Date: 2024.05.10
Project Name: KCKHA Parking Repairs, Package #2
Veritas Project #: 22.39

i. D00, PARKING LOT REPAIR PLAN (DOUGLAS HEIGHTS HIGH RISE):

ii. R00, PARKING LOT REPAIR PLAN (ROSEDALE TOWERS):

C1.0

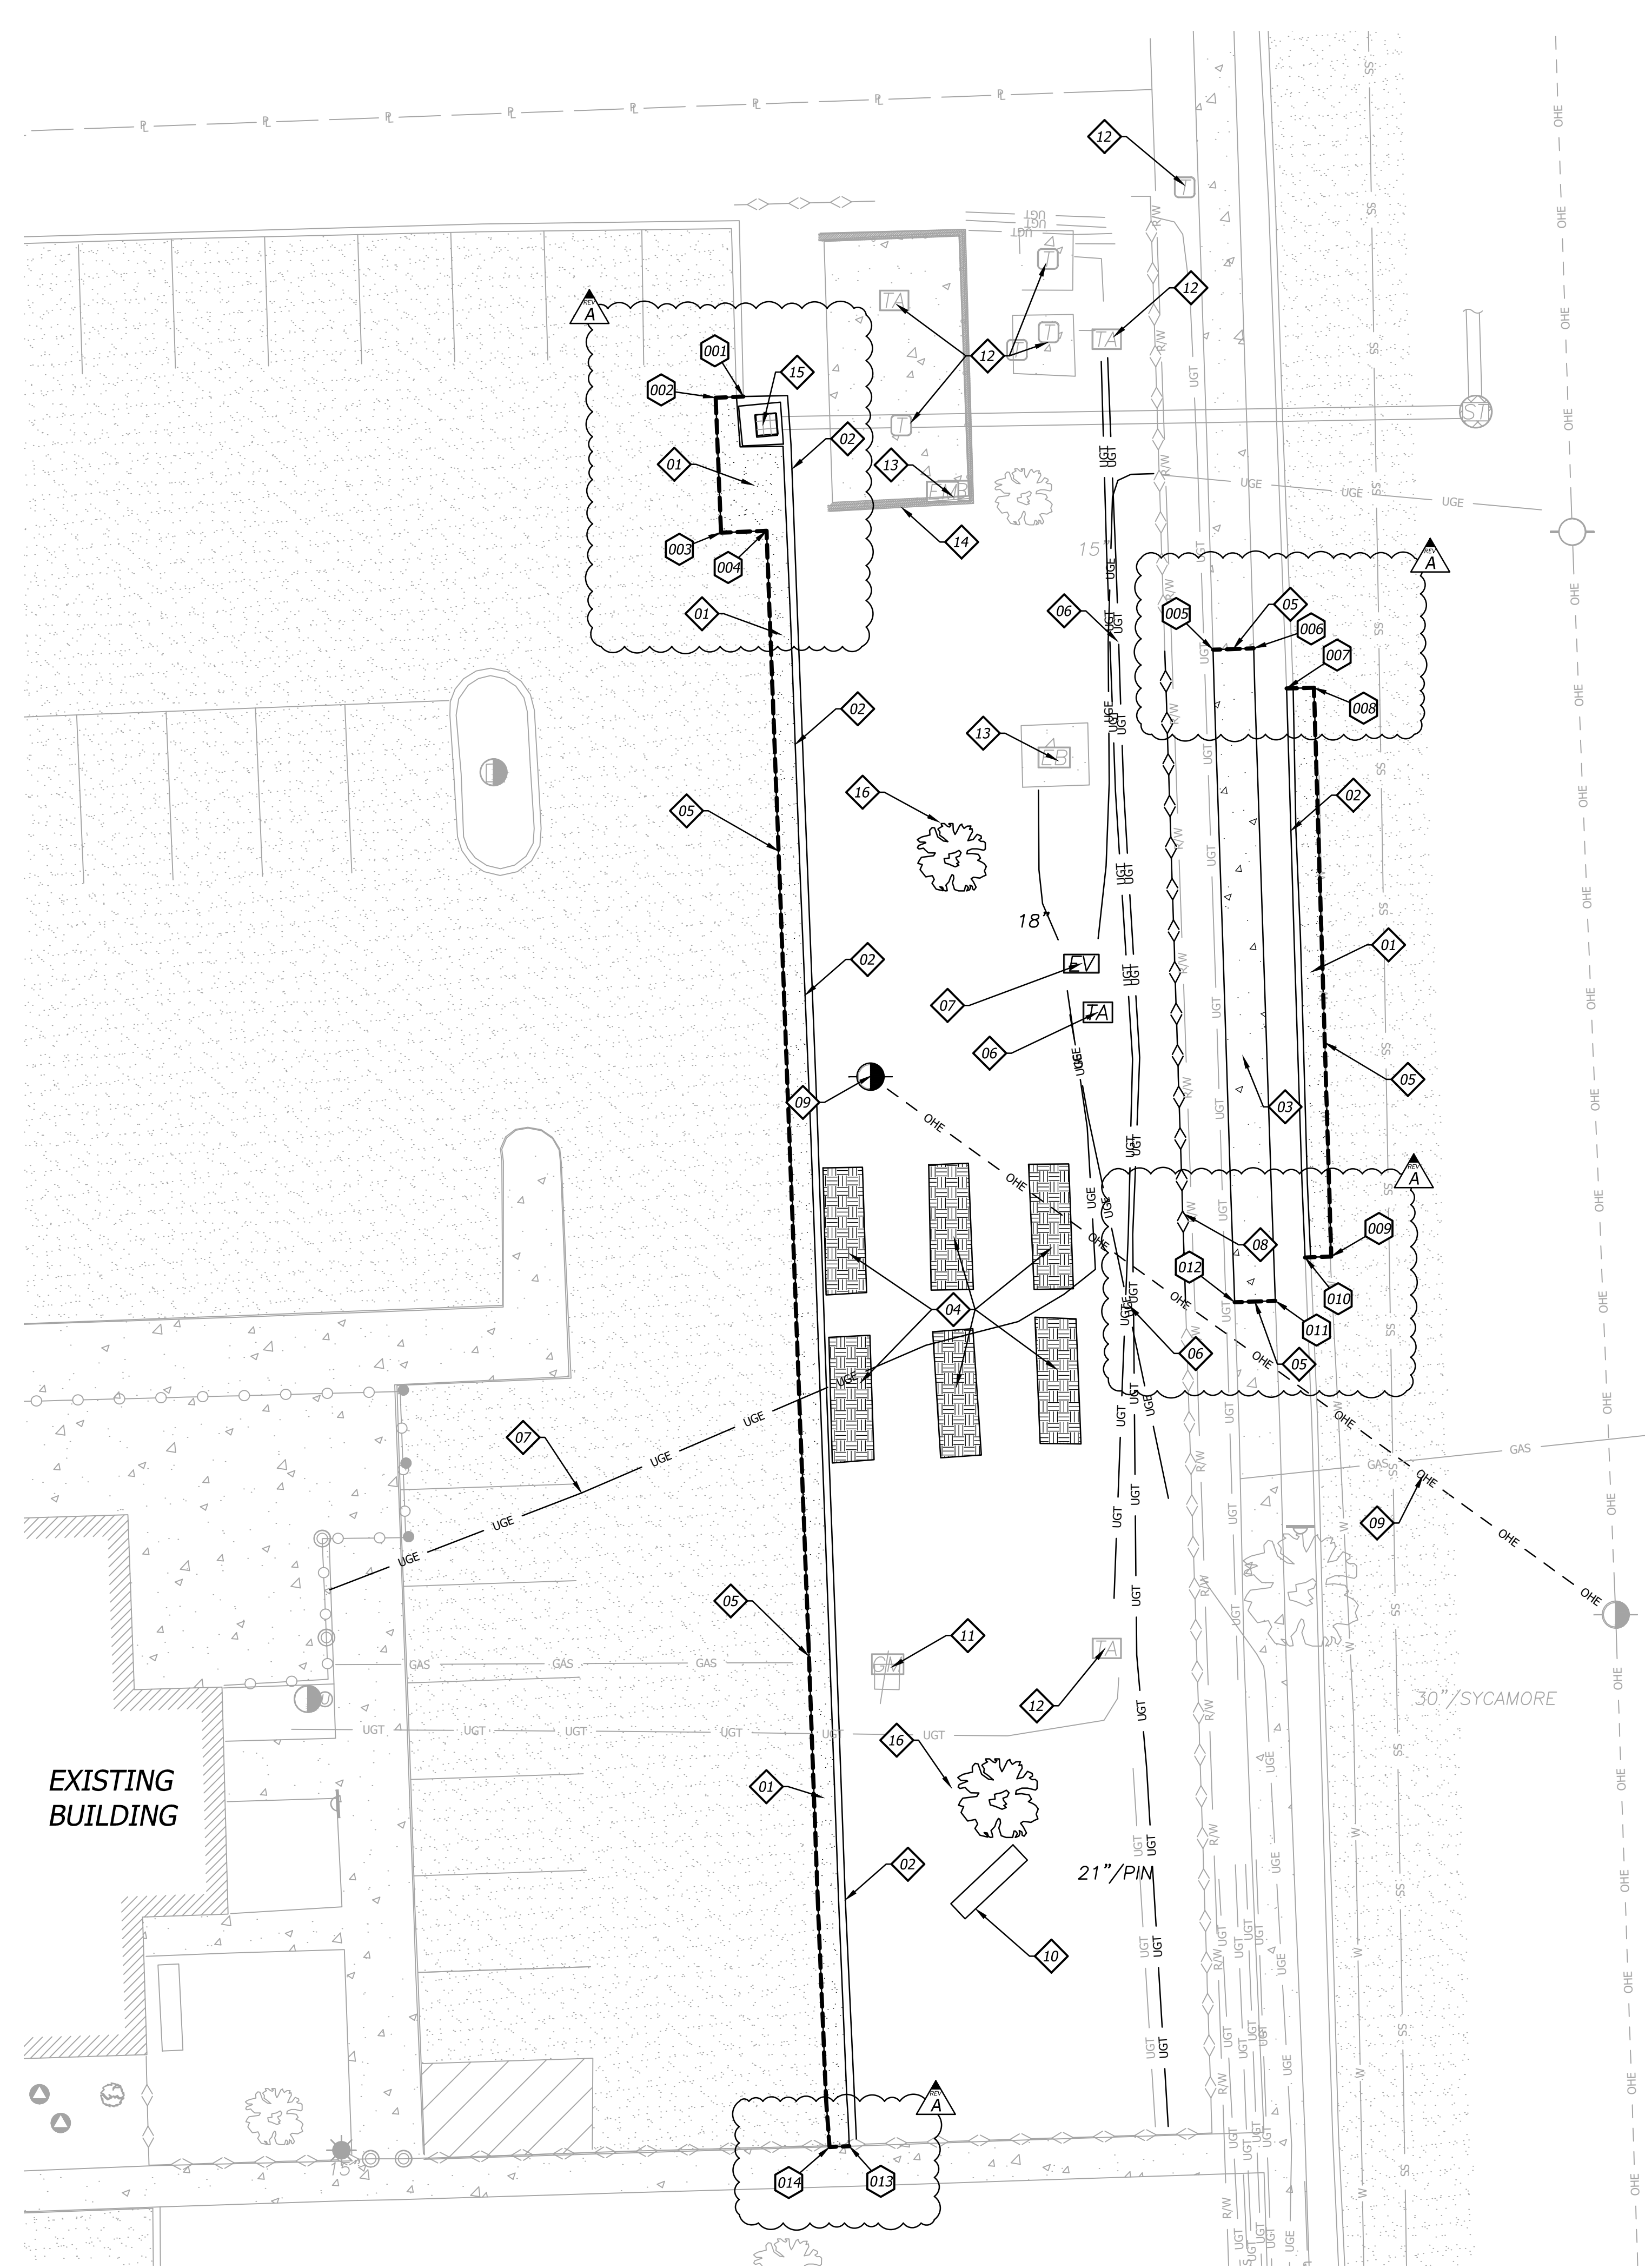
1. Added replacement of existing storm inlet top.
2. Updated demolition coordinate points

Q: C1.0 general note 7 calls out for 6' construction fencing at the project site if required by the owner or city – is this required?

A: Construction fencing not mentioned in KCK UG design guidelines. Contractor to confirm fencing requirements w/ KCK UG. Owner (KCKHA) does not require construction fencing.

C3.0

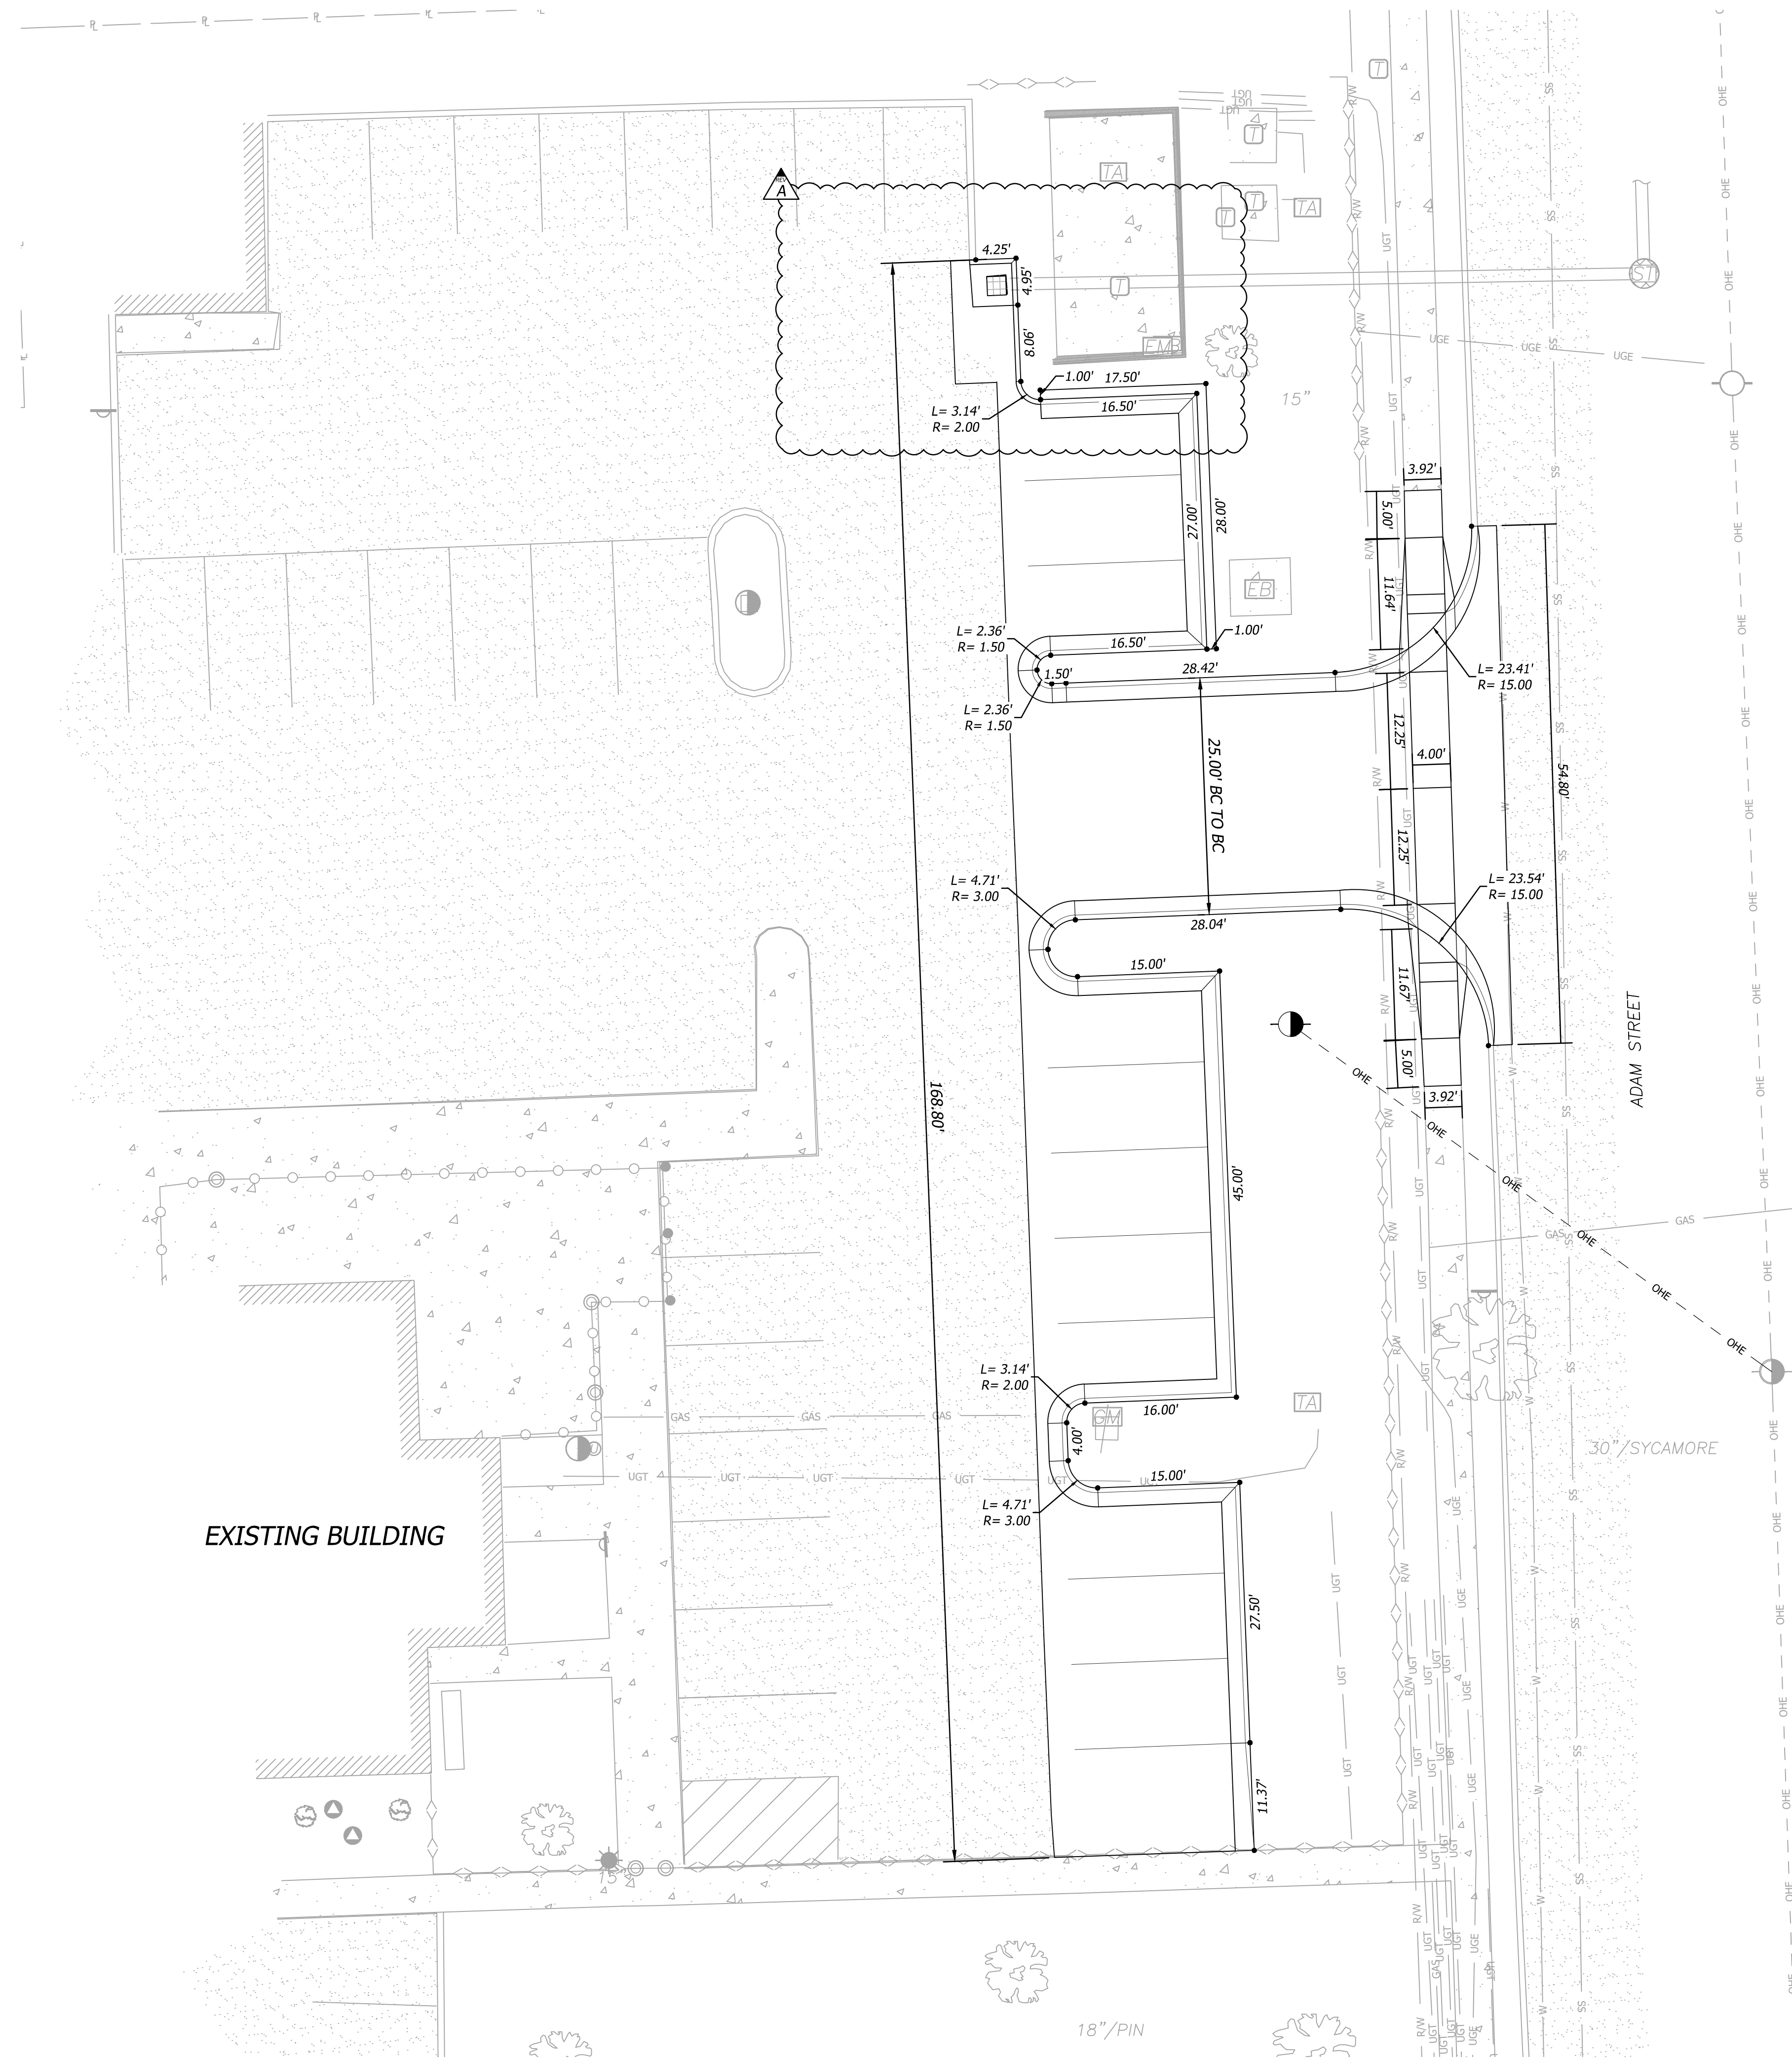
1. Updated dimensions to reflect storm inlet top replacement.
